GEORGIA DEPARTMENT OF TRANSPORTATION

SR 32 @ Flint River and Overflow

BRSTO-0031-01(042) PI# 432092-

VALUE ENGINEERING REPORT

ALTERNATIVE NO.:
GR-2

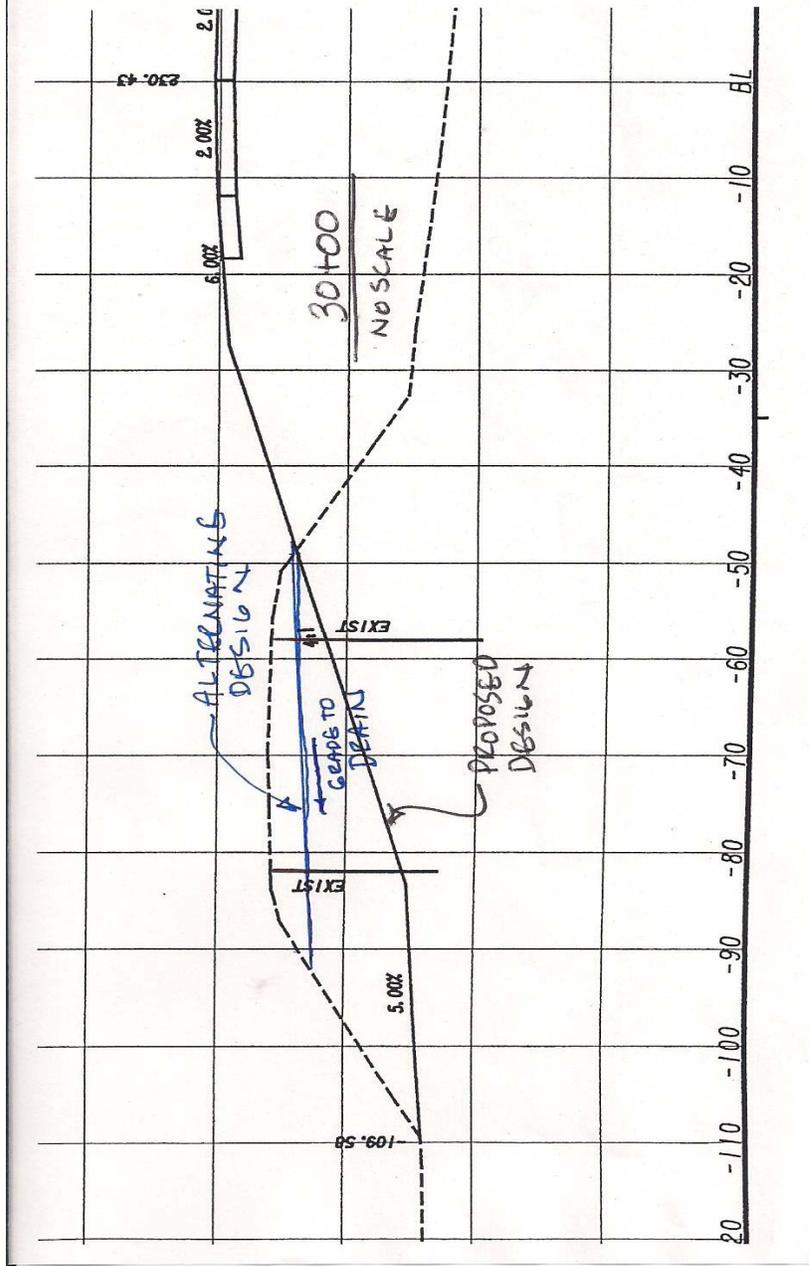
The original design calls for removal of most of the existing roadway, constructing a 4:1 shoulder front slope through most of the project.

The alternative would obliterate the existing pavement on the old roadway and thence re-grade the existing roadbed in-lieu of "wasting" the material, resulting in a final side slope of something less than the 4:1 proposed.

The alternative seeks to minimize the amount of unclassified excavation required to provide drainage for the new roadway by minimizing removal of the existing roadway. The original design would create 4:1 front slopes of the new roadway requiring removal of a substantial portion of the old roadway. The alternative would obliterate the old pavement, and grade to drain. It is noted that the original design does not have unclassified excavation included in the summary of quantities provided. Using the staging as planned would not allow incorporation of the unclassified excavation of the old roadway to be utilized as borrow for fill for the new roadway.

ALTERNATIVE NO.:
BR#1-4

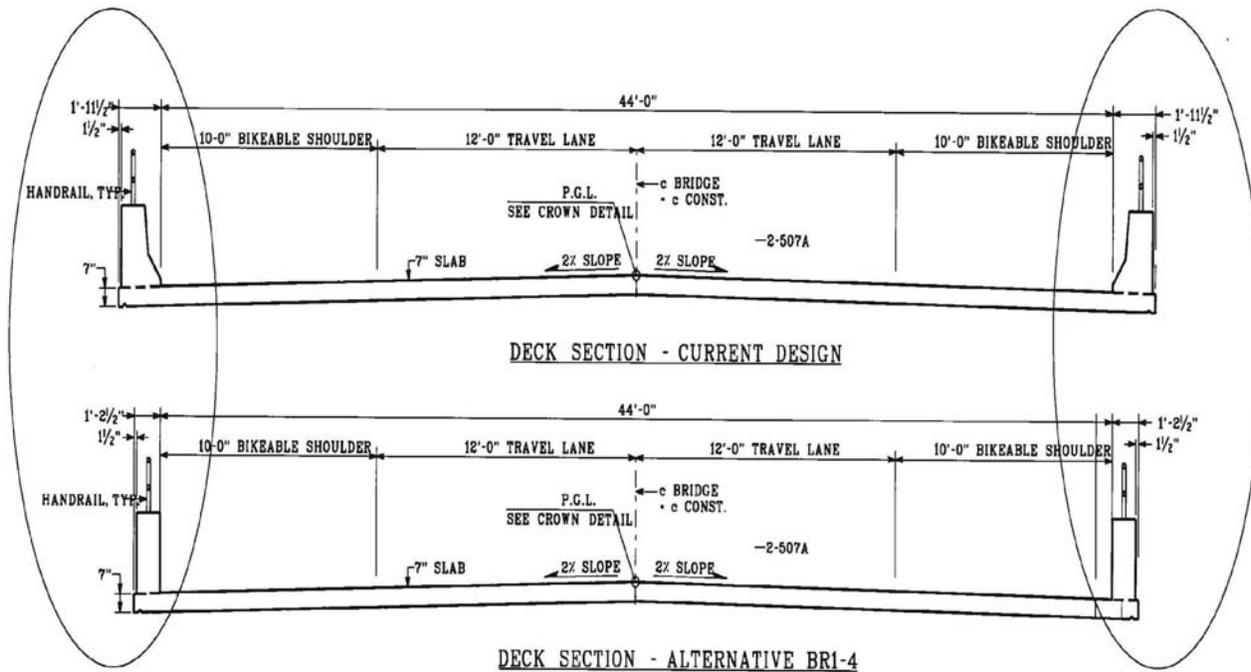
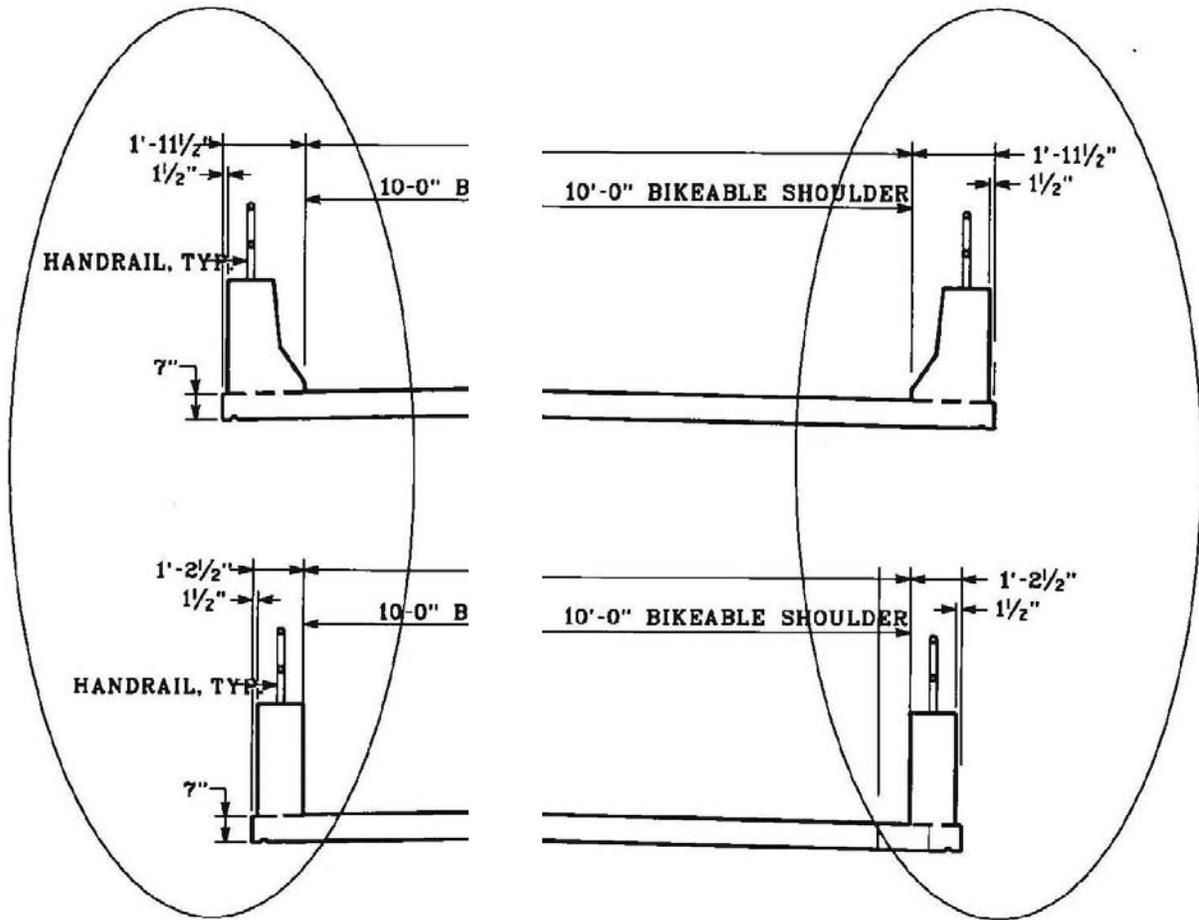
The alternative design proposes utilizing Special Design rails in-lieu of Jersey rails to reduce deck width requirement.

Special Design rails of 1'-1" can be used in-lieu of the Jersey Rails of 1'-10". The net reduction in deck width would be 18" (1'-6").

Current Design: Total width 47'11"

Alternate Design: Total width 46' 5"

ALTERNATIVE NO.:
BR #1-5

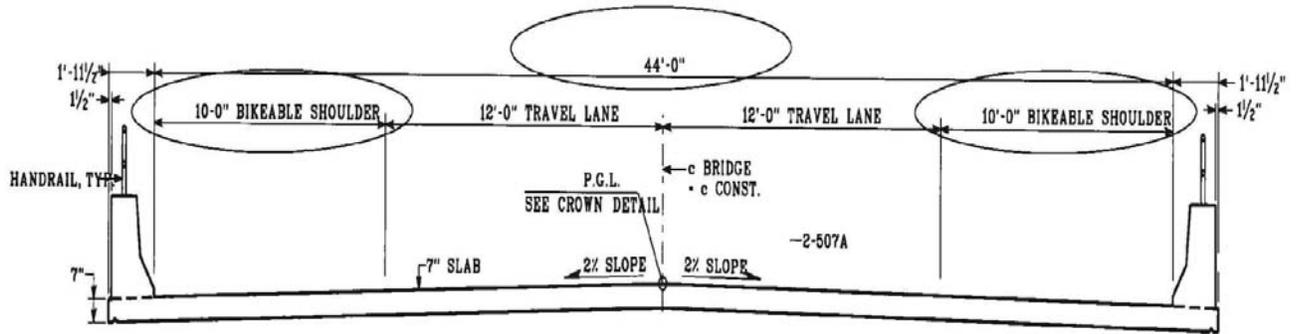
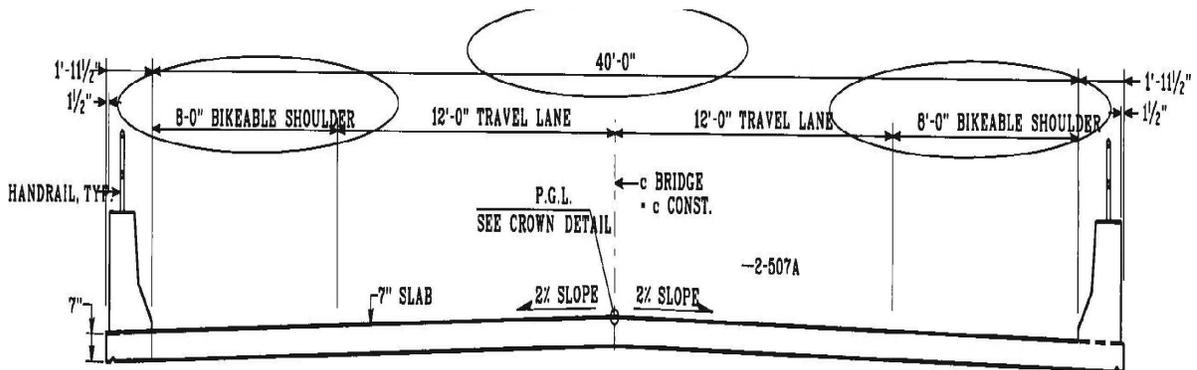
The alternative design proposes 8' shoulders in-lieu of 10' shoulders to reduce the deck width by 4'.

Per Page 425 of AASHTO's "A Policy on Geometric Design of Highways and Streets" and as quoted in GDOT MOG 4265-10 8' shoulders are adequate on a rural arterial with ADT over 2000. 8' shoulders on the bridge will also accommodate a bicycle path.

DECK SECTION - CURRENT DESIGN

DECK SECTION - ALTERNATIVE BR1-5

ALTERNATIVE NO.:
BR #2-2

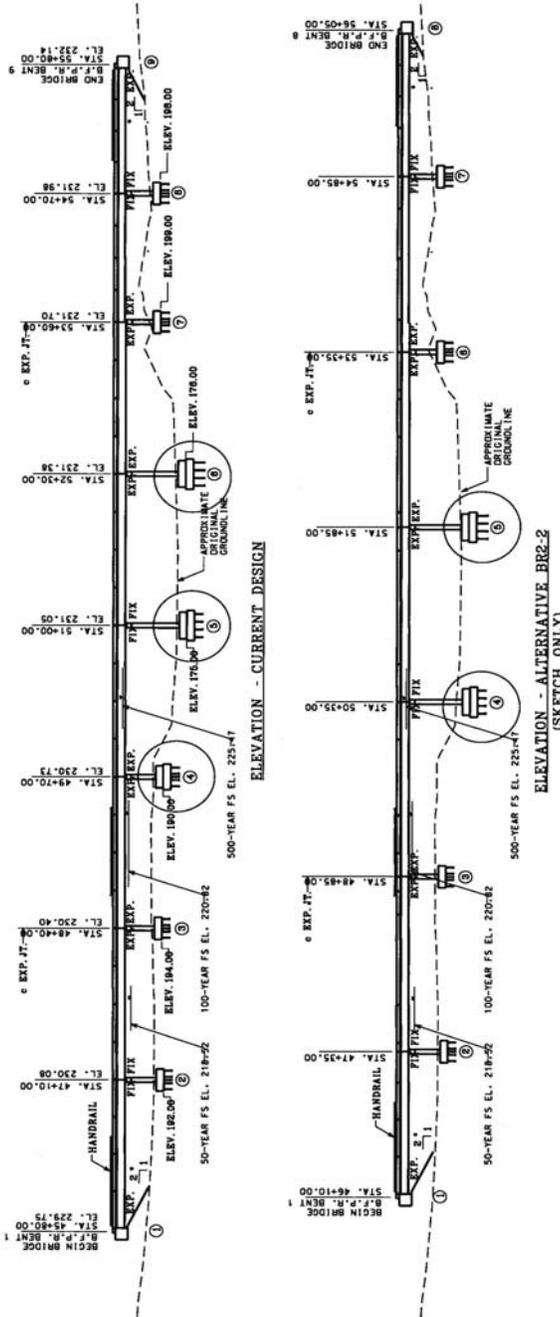
The alternative design proposes utilizing the optimum capacity of BT-74 Girders to provide 150' span lengths resulting in the elimination of one span, and therefore, one interior bent and associated cofferdam. The span arrangement in this alternative provides 7 spans.

Maximum span lengths of 166' can be achieved by using BT-74 Girders made of higher strength concrete ($f'c = 8$ to 10 ksi). The revised span configuration can be 2 @ 125' = 250', BT-74; 5 @ 150' = 750', BT-74. In order to center the main span over the navigation channel while maintaining the 1000' length, the Begin and End Stations of bridge may have to be adjusted slightly.

ALTERNATIVE NO.:
BR #2-4

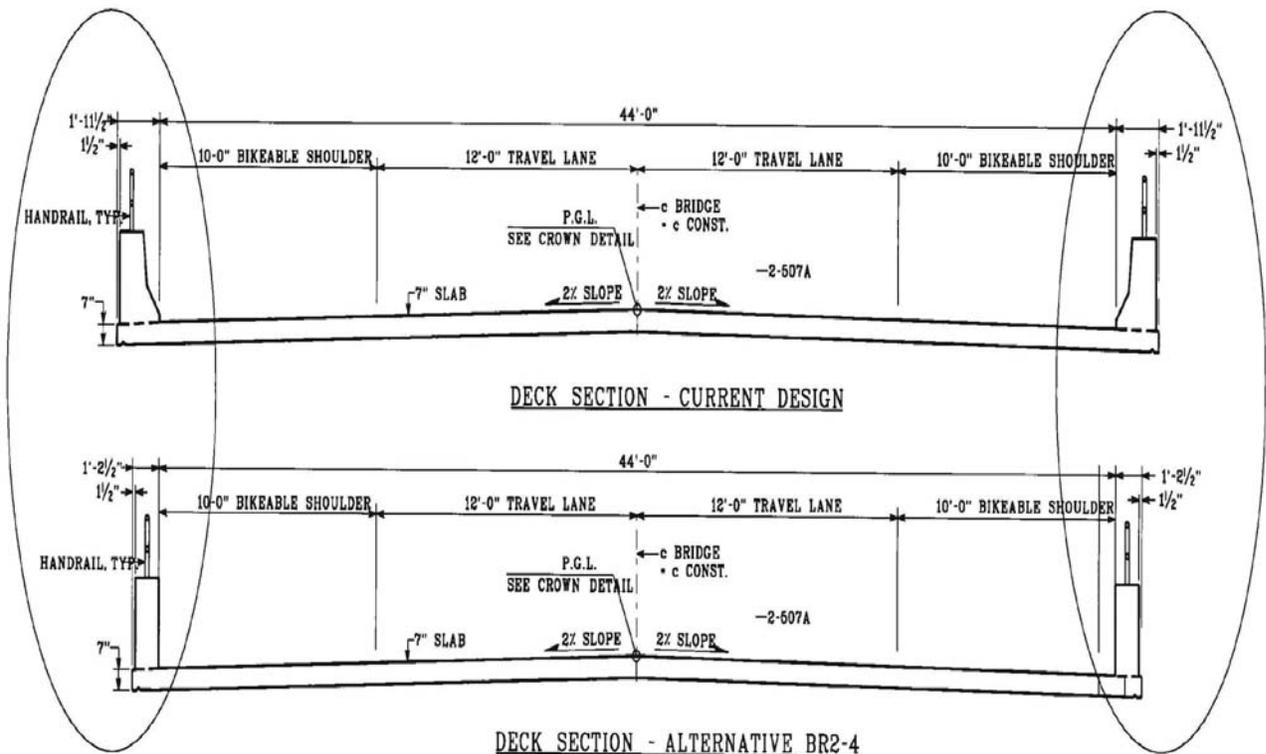
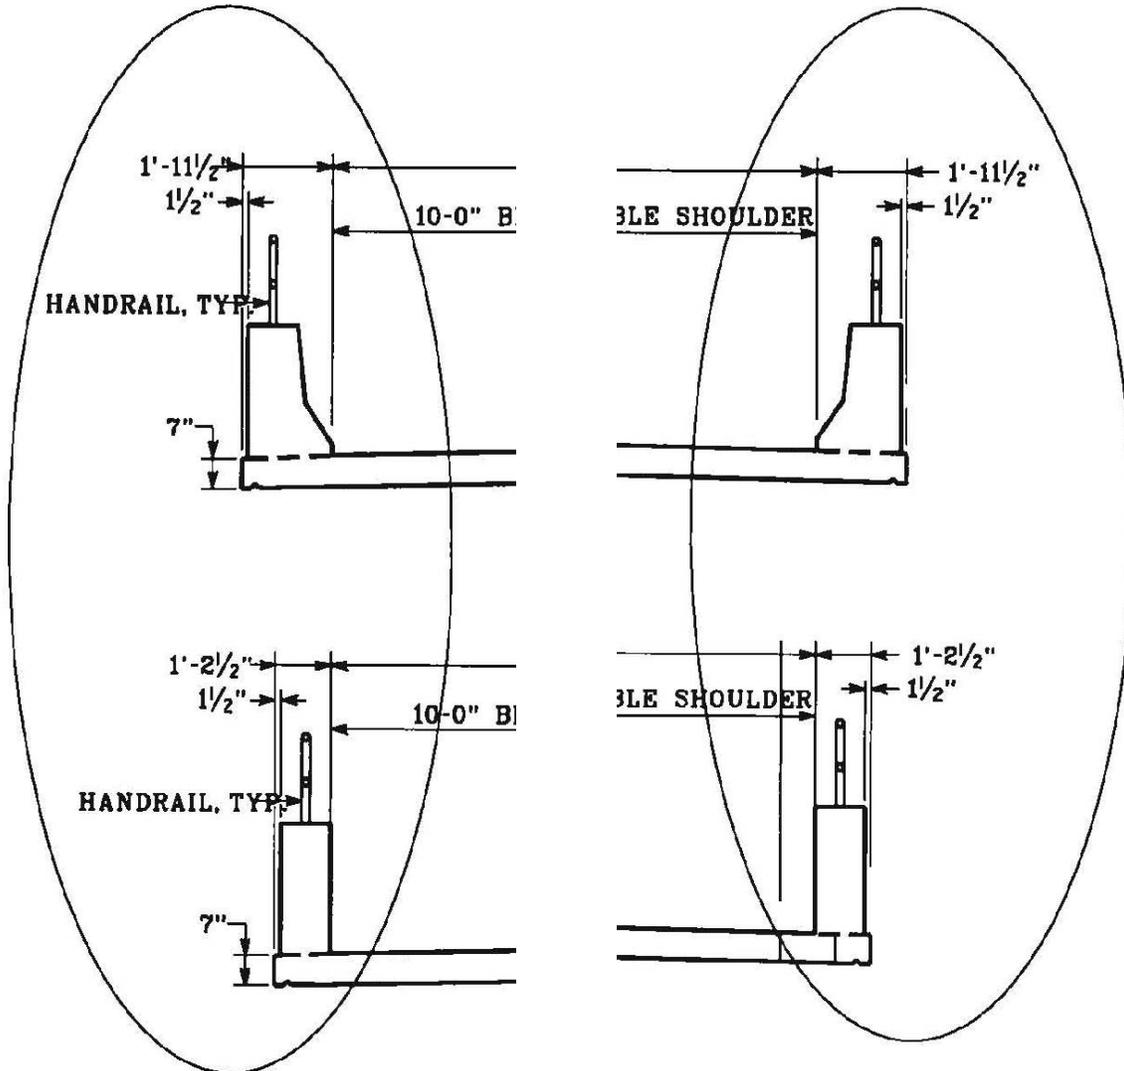
The alternative design proposes utilizing Special Design rails in-lieu of Jersey rails to reduce deck width requirement.

Special Design rails of 1'-1" can be used in-lieu of the Jersey Rails of 1'-10". The net reduction in deck width would be 18" (1'-6").

End Sections shown for clarity reflecting a narrowing of the bridge overall width

ALTERNATIVE NO.:
BR #2-5

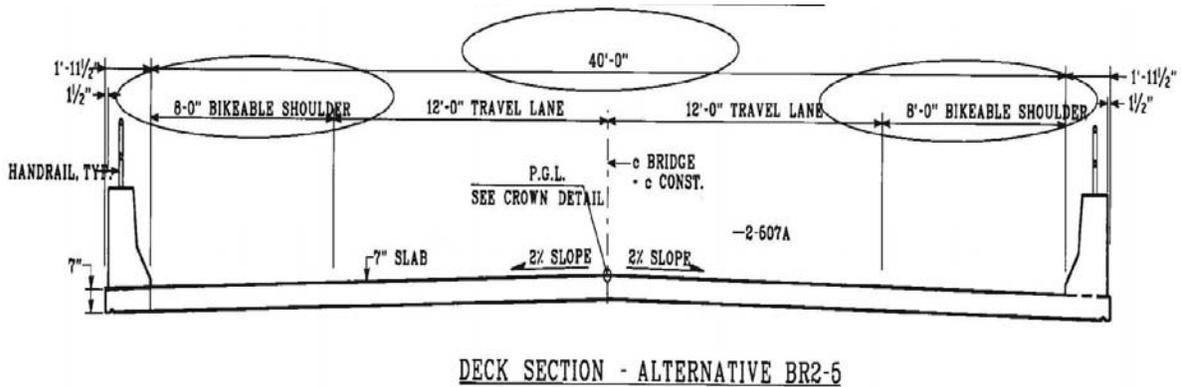
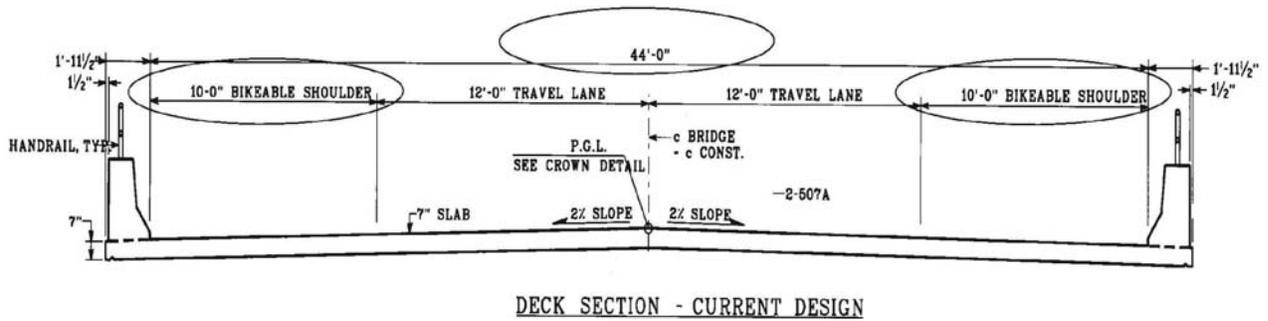
The alternative design proposes 8' shoulders in-lieu of 10' shoulders to reduce the deck width by 4'.

Per Page 425 of AASHTO's "A Policy on Geometric Design of Highways and Streets" and as quoted in GDOT MOG 4265-10 8' shoulders are adequate on a rural arterial with ADT over 2000. 8' shoulders on the bridge will also accommodate a bicycle path.
